Photo 9 view of bell showing the broken sound bow, and the headstock thinned on its S side by rust.

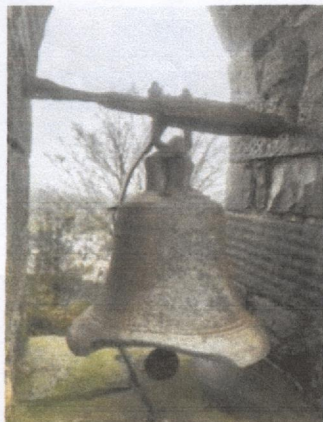
The Diocesan Bell Advisor, Peter Hayward has reported on the historic C15 bell. The bell and its hanging are in a seriously poor condition [see Photo 9, Photo 8]: the headstock holding the bell is severely corroded on one side and could bend and collapse at any moment, while the **gudgeon** on the N side of

the headstock supporting the bell only engages some 10 mm with its bearing.

The bell should not be rung, and the bell should be taken down as soon as possible to keep it safe from falling. Its repair¹¹ and rehanging should then be planned, ideally within this coming quinquennium.

¹¹ This should include the specialist welding in of a new section of sound bow unless the fragment broken off has been found and kept safe, in which case that should be welded back in. The work will need to be done by Soundweld, a firm in Newmarket that specialise in this, the only firm in Europe who do this.
